Comment Responses for the Nuclear Regulatory Commission Request for Additional Information on the Draft Waste Incidental to Reprocessing Evaluation for Waste Management Area C

Date Published
October 2019

This document provides DOE's responses to the NRC staff RAIs, to facilitate NRC's completion of a Technical Evaluation Report (TER) on the Draft WIR Evaluation. For each of the 21 RAIs, the NRC comment, basis information, and proposed path forward is quoted directly as received from NRC (with minor typographical corrections). These are followed by DOE's response. The topics discussed herein are technical in nature. Although DOE has attempted to present this information in an accessible manner, it cannot be considered a stand-alone document. The RAIs and responses are part of the on-going interaction between DOE and NRC staff regarding the review of the Draft WIR Evaluation and the associated WMA C PA, and can only be understood in that context; a working knowledge of those documents is assumed.

Figure 17. Dose distribution for the new combined alternative conceptual model sensitivity analysis case for the combined failure of multiple safety functions.

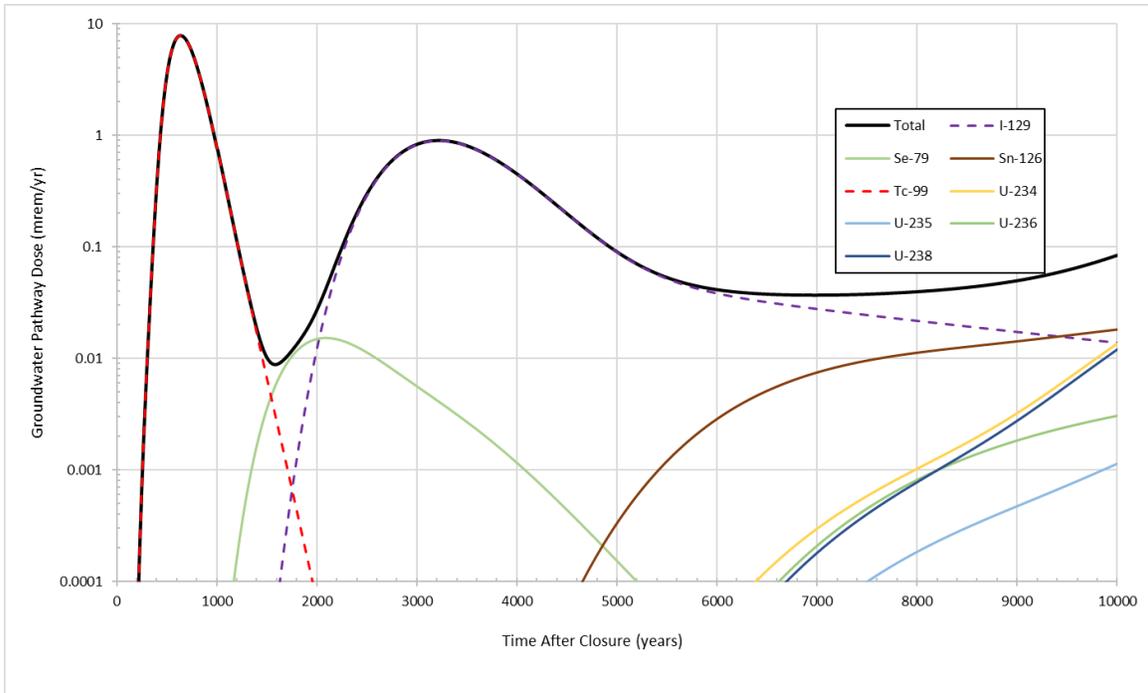
The uncertainty analysis appears to be focused on the evaluating the range of variability of the input parameter values for the base case and is not able to identify plausible alternative conceptual models. An assumption that there is only one plausible future scenario (i.e., no alternative future scenarios) with a non-dynamic environment for 10,000 year requires a rigorous technical basis. Results of analyses should evaluate the interdependencies and interrelationships between components of the system and provide supporting evidence of plausible alternative scenarios or conceptual models.

Please provide a description of the approach to identifying plausible alternative conceptual models or alternative future scenarios used in development of the WMA C PA, or clarify how DOE’s current safety function methodology would identify interdependencies and interrelationships that may lead to plausible alternative models or scenarios.

DOE emphasizes that this is not an analysis that represents a credible representation of system behavior, as there is substantial evidence supporting the base case assumptions. Furthermore, this type of extreme analysis is not generally valuable for decision making. This analysis provides an overly conservative estimate of facility performance and may lead to an unduly pessimistic idea of system performance. However, specifically for WMA C, this analysis has been conducted to demonstrate the robustness of the system performance, and to demonstrate that the uncertainty analysis presented in the WMA C PA is appropriate for its purpose.

The results of the new combined alternative conceptual model sensitivity case analysis are presented in Figure 17. Dose distribution for the new combined alternative conceptual model sensitivity analysis case for the combined failure of multiple safety functions.. The maximum total dose of 7.8 mrem/year occurs at about 640 years after assumed closure date of 2020, and the primary dose contributing radionuclide is Tc-99. The peak dose remains far below the performance limit of 25 mrem/year for the all-pathways scenario within the 1000 year compliance period. As the dose contribution from Tc-99 declines, the contributions from I-129 and Se-79 increases resulting in a second peak of 0.90 mrem/year in the post-compliance time period. Uranium isotopes contribute to the dose only after 5000 years.
